RE: DRB APPROVAL NOTIFICATION

Case Reference No: 56-DR-2016 Peacock Scottsdale

DEVELOPMENT REVIEW BOARD REPORT

Peacock Scottsdale 56-DR-2016

DRB Stipulations

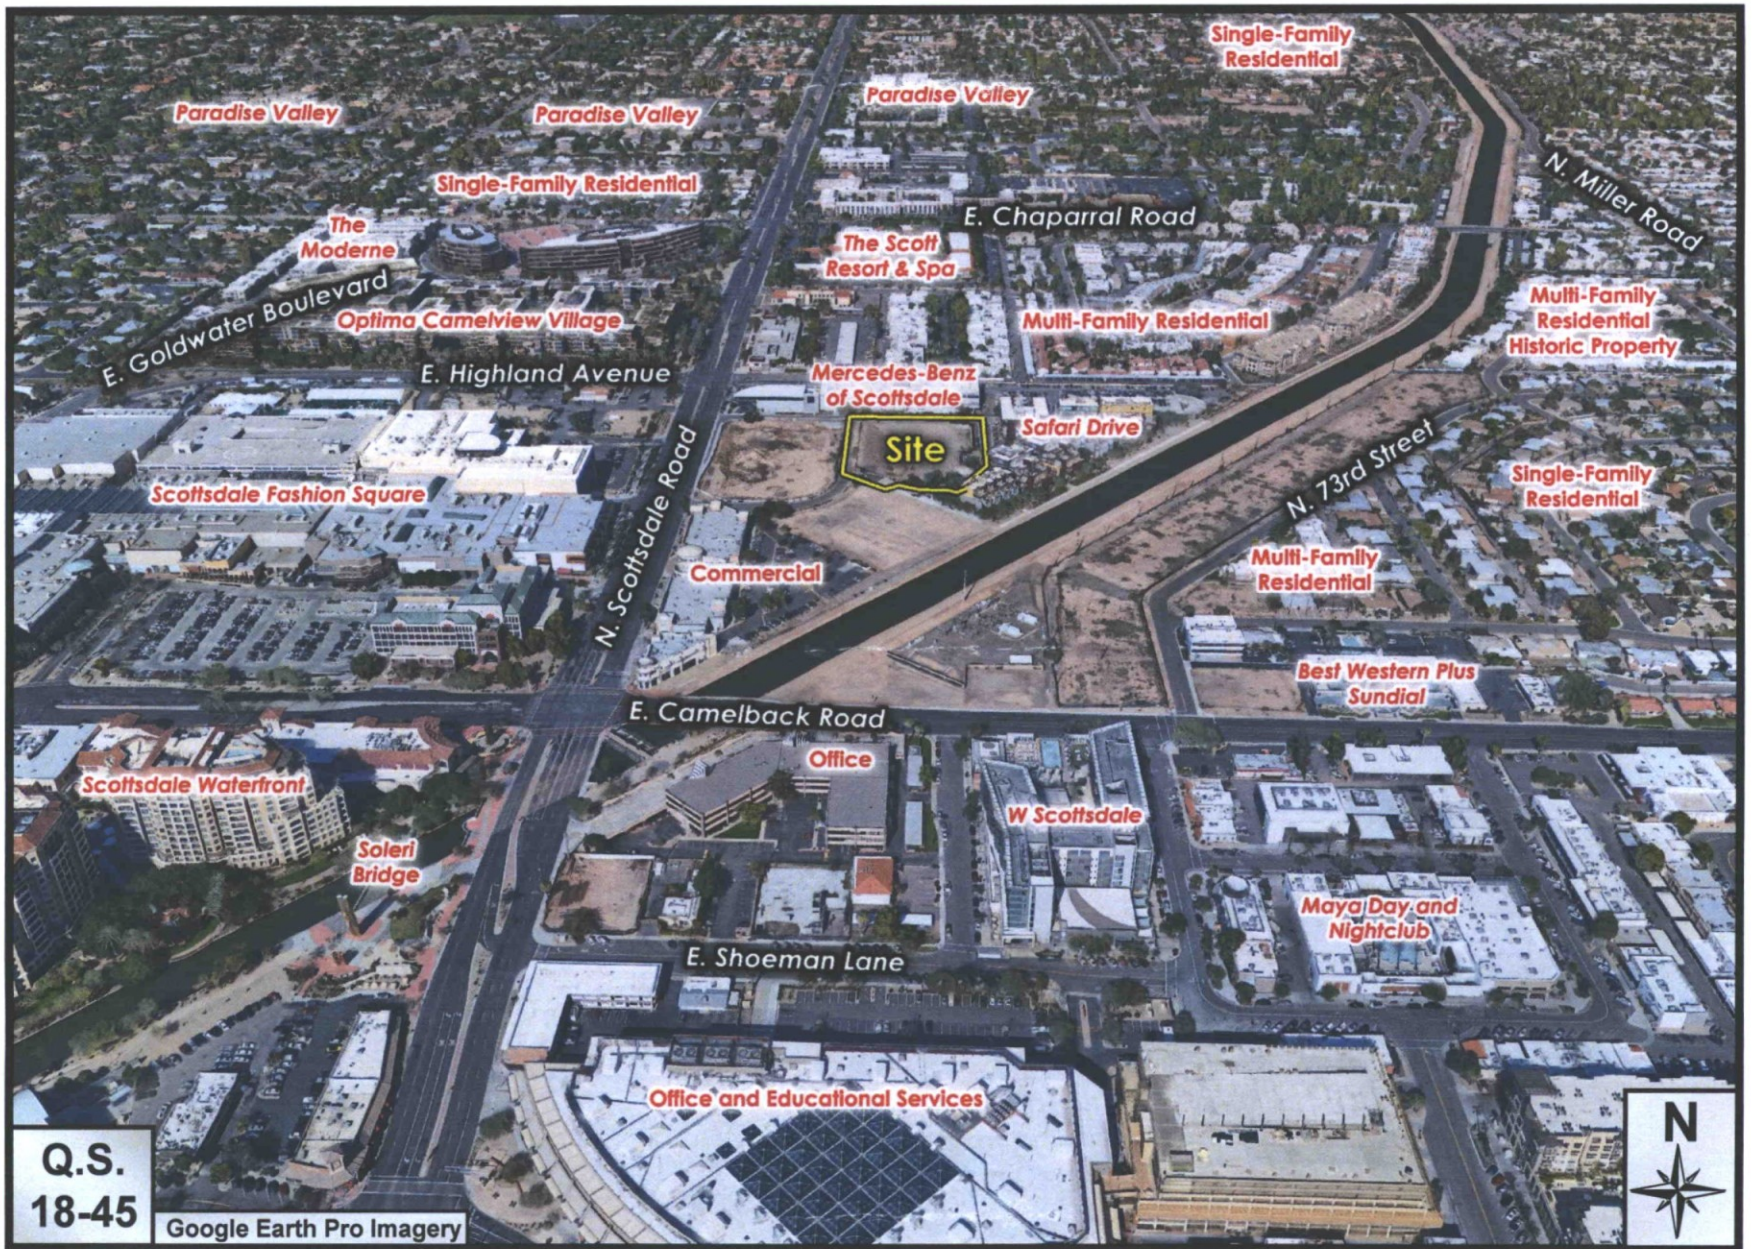
11. As delineated and described in Attachment 1 of Attachment A, abutting the buildings and site walls, the owner shall submit construction documents to construct raised landscape planters. Gaps with a maximum width of six (6) feet may be provided in the length of the planter to provide for entry and exit doors to the building or court yard, and the backflow preventer.

12. As delineated and described in Attachment 1 of Attachment A, adjacent to the east curb of the North 72nd Place alignment driveway, the owner shall provide landscape planters with trees between the driveway into the Safari Phase 1 development on the southwest corner of the development and the transformers located at the northwest corner of the development. No planter shall be provided in the public non-motorized access easement between the buildings and North 72nd Place alignment driveway. Planters shall be equal to the size and spacing of the three planters located directly south of the East Cooldige Drive alignment driveway, and between the northeast corner of the development and the generator room. These planters shall be designed with materials and finishes to match Safari Phase 1 raised planters between the east side of the North 72nd Way alignment driveway and the Safari Phase 1 building.

13. Planters located directly south of the East Cooldige Drive alignment driveway, between the northeast corner of the development and the generator room, and the planters that are directly west of the North 72nd Way alignment driveway, between the driveway and the building, shall be designed with materials and finishes to match Safari Phase 1 raised planters that are located between the east side of the North 72nd Way alignment driveway and the Safari Phase 1 building.

15. The maximum height of all raised planters shall be thirty-two (32) inches above adjacent finish grade.
16. Raised landscape planters shall have minimum thirty-two (32) inches of soil depth, and additional depth shall be provided to support the root system of a tree that is to be located in a planters.

- A PLANTER SHALL BE A MINIMUM FIVE (5) FOOT WIDE, MAXIMUM THIRTY-TWO (32) INCHES TALL, AND HAVE A MINIMUM LENGTH OF 40 FEET
- B PLANTER SHALL BE A MINIMUM FIVE (5) FOOT WIDE, MAXIMUM THIRTY-TWO (32) INCHES TALL, AND HAVE A MINIMUM LENGTH OF 25 FEET

- C PLANTER SHALL BE A MINIMUM FIVE (5) FOOT WIDE, MAXIMUM THIRTY-TWO (32) INCHES TALL, AND HAVE A MINIMUM LENGTH OF 38 FEET
- D PLANTER SHALL BE A MINIMUM FIVE (5) FOOT WIDE, MAXIMUM THIRTY-TWO (32) INCHES TALL, AND HAVE A MINIMUM LENGTH OF 17 FEET

- E PLANTER SHALL BE A MINIMUM FIVE (5) FOOT WIDE, WITHIN THE PUBLIC NON-MOTORIZED ACCESS EASEMENT, ABUTTING THE SOUTH EASEMENT LINE, MAXIMUM THIRTY-TWO (32) INCHES TALL, AND SHALL EXTEND THE ENTIRE LENGTH OF THE BUILDING WALL FROM THE CORNER OF BUILDING ON THE E END, AND WRAPPING THE CORNER OF THE BUILDING ON THE WEST END, AND EXTENDING SOUTH A MINIMUM OF 24 FEET, AS DELINEATE ON THE PLAN

- F PLANTER SHALL BE A MINIMUM FIVE (5) FOOT WIDE, WITHIN THE PUBLIC NON-MOTORIZED ACCESS EASEMENT, ABUTTING THE SOUTH EASEMENT LINE, MAXIMUM THIRTY-TWO (32) INCHES TALL, AND SHALL EXTEND THE ENTIRE LENGTH OF THE BUILDING 2 AMENITY AREA PLANTER, AS DELINEATE ON THE PLAN

ALL PLANTERS SHALL BE MINIMUM FIVE (5) FOOT WIDE, MAXIMUM THIRTY-TWO (32) INCHES TALL, HAVE A MINIMUM LENGTH OF 10 FEET, AND BE DESIGNED WITH MATERIAL AND FINISHES TO MATCH SAFARI PHASE 1 RAISED PLANTERS BETWEEN THE EAST SIDE OF THE NORTH 72ND WAY ALIGNMENT DRIVEWAY AND THE SAFARI PHASE 1 BUILD

PLANTER SHALL BE A MINIMUM FIVE (5) FOOT WIDE BETWEEN THE WALL THAT SEPARATES THE BUILDING 1 AMENITY AREA AND THE PUBLIC NON-MOTORIZED ACCESS EASEMENT, THE PLANTER MAYBE PLACED A MAXIMUM TWO (2) FEET SIX (6) WITHIN THE PUBLIC NON-MOTORIZED ACCESS EASEMENT ON THE NORTH SIDE OF THE PUBLIC NON-MOTORIZED ACCESS EASEMENT, MAXIMUM THIRTY-TWO (32) INCHES TALL, AND SHALL EXTEND THE ENTIRE LENGTH OF THE BUILDING 2 AMENITY AREA PLAN FROM THE CORNER OF, AS DELINEATE ON THE PLAN, THE WEST END OF THE PLANTER MAY TAMPER TO A LESS WIDTH AS DELINEATED ON THE PLAN.

**BUILDING 1
 NORTH ELEVATION**
 06/06/17

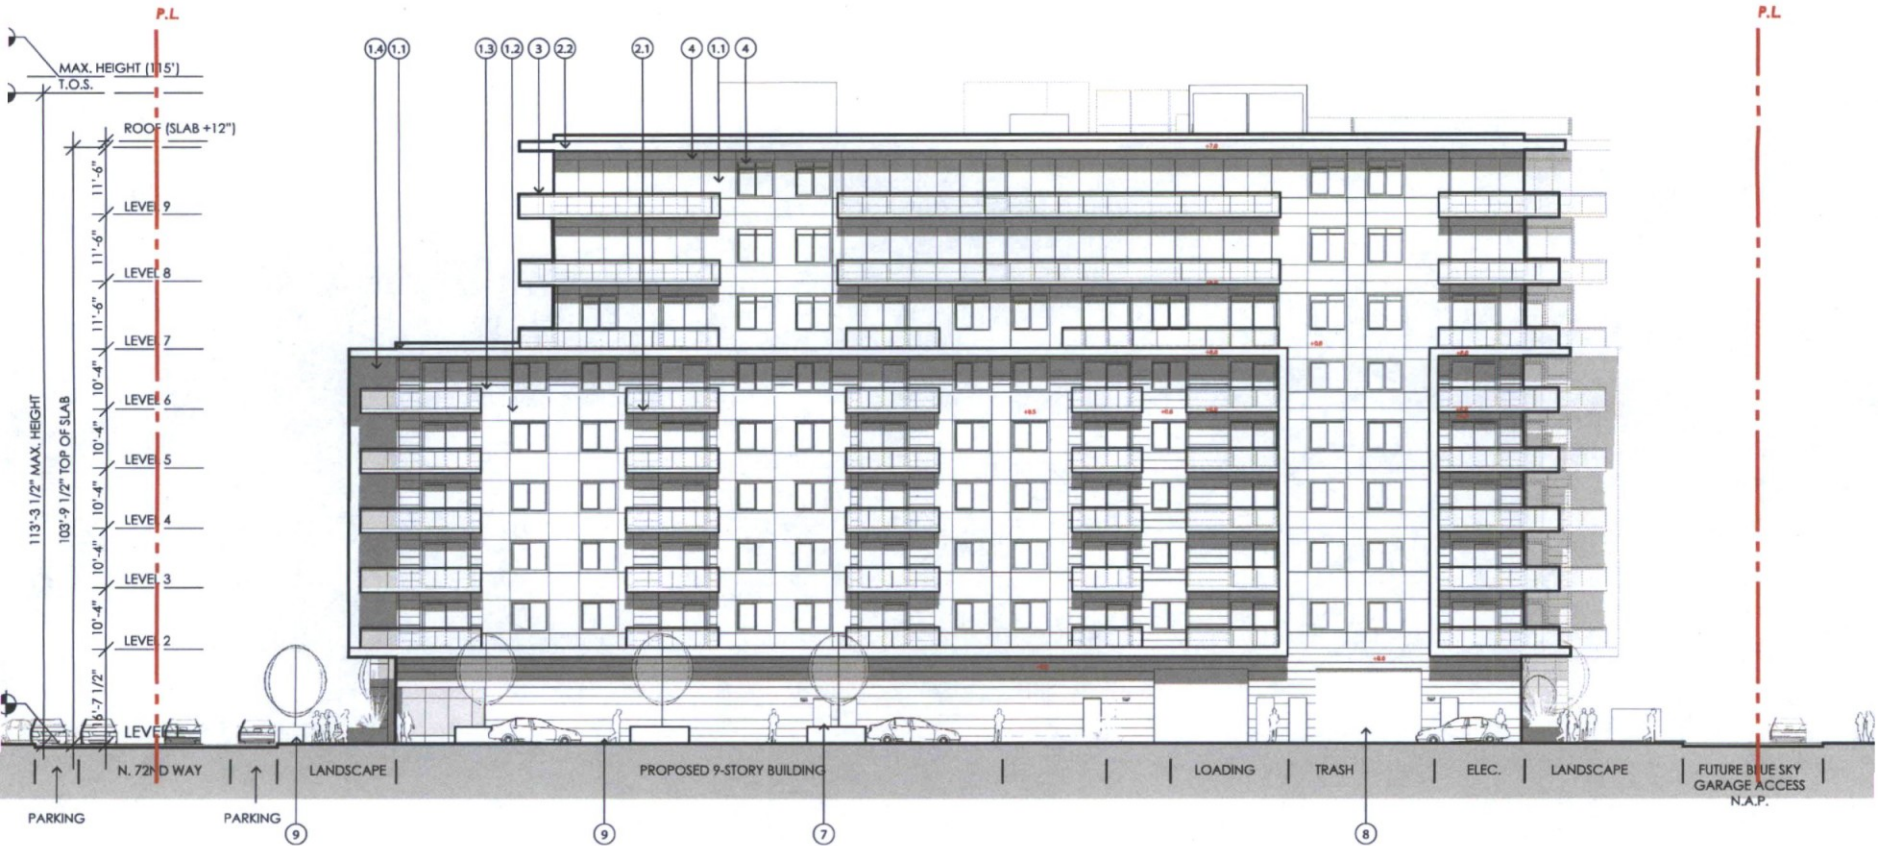
- C. In accordance with the amended development standards for Encroachments Beyond Inclined Stepback Plane (Sections 5.3060, Schedule B.III.7, and 5.3063.A), the top floor and projects of the north elevation shall be revised so that no projection beyond the stepback plane is greater than twenty-five percent of the length of the building. The owner shall submit a separate Development Review Board application to obtain approval of the building elevation design that is in compliance with the amended development standards.
- D. Before any building permit is issued for the site, the owner shall submit and obtain approval of the construction documents demonstrating that the roof drainage systems, excluding scuppers, shall be concealed within the structure.
